## SITE AUDIT REPORT AND SITE AUDIT STATEMENT

# Caddens Release Area C, Kingswood, NSW, 2747

**Report Number.** 097623019\_014\_R\_Rev0

**Statement Number:** RJP024

**Figure 12** Groundwater Flow

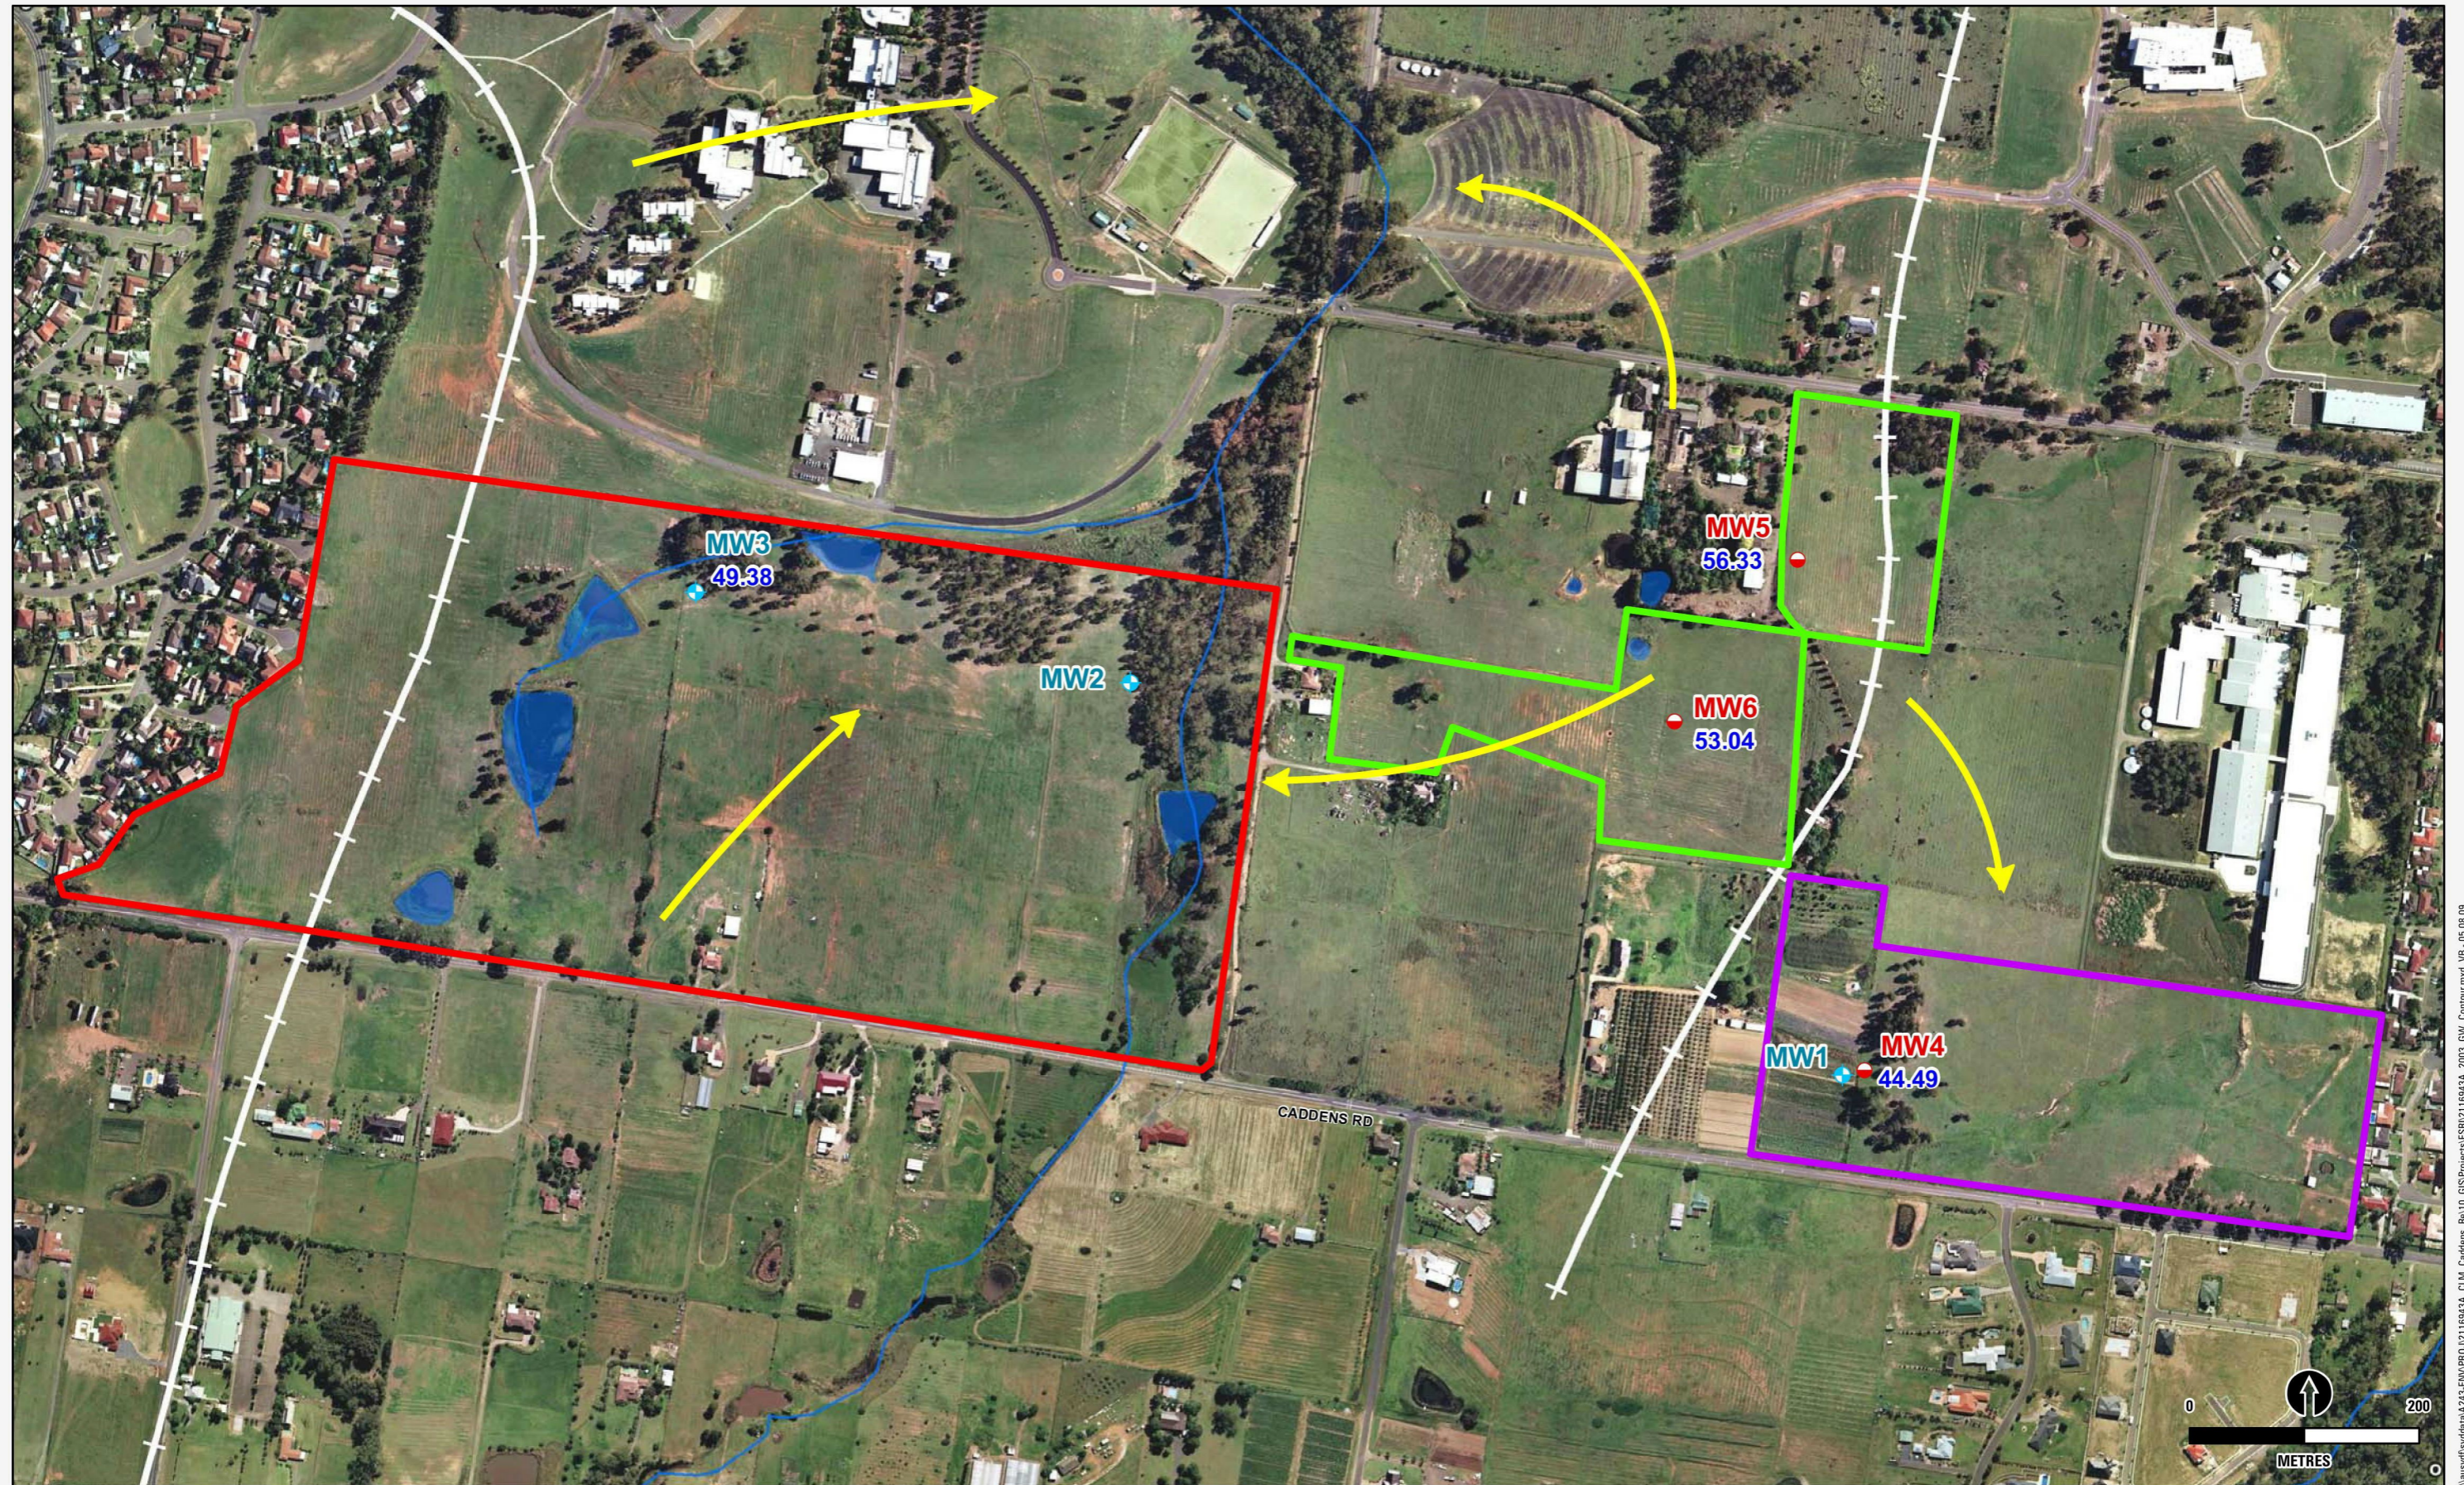
Table 8-4 references Figure 12 which presents interpreted groundwater contours which are plotted to flow in a southerly direction radiating from well MW5. This interpretation contradicts the direction of flow inferred from published information (Section 3.4), and the direction of flow of the creek that bisects the Site.”

The Site is bisected by Werrington Creek that flows to the north. Monitoring wells MW4-MW6 and MW3 are located on the western side eastern side of the creek respectively. The interpretation of groundwater flow on Figure 12 (PB, 2009b) was undertaken incorrectly by contouring the elevation of the watertable and ignoring the influence of the drainage lines. It is assessed there is insufficient data to contour the groundwater elevation to produce a potentiometric head contour map.

Reference to the topographic map indicates the Site is intersected by catchment boundaries to the east and west as shown on Figure 12. The watertable elevation in an unconfined aquifer is typically a subdued reflection of the topographic surface. Groundwater flow is inferred to be perpendicular to the catchment boundary and towards the creek systems. Thus groundwater flow at the eastern part of the Site is radial from MW5 (centred on a local topographic high) and elsewhere generally northward flowing in the direction of Werrington Creek. Analysis of groundwater levels from monitoring wells MW4, MW5 and MW6 confirm local groundwater flow (in the south eastern part of the Site) is in a south-westerly direction towards Werrington Creek.
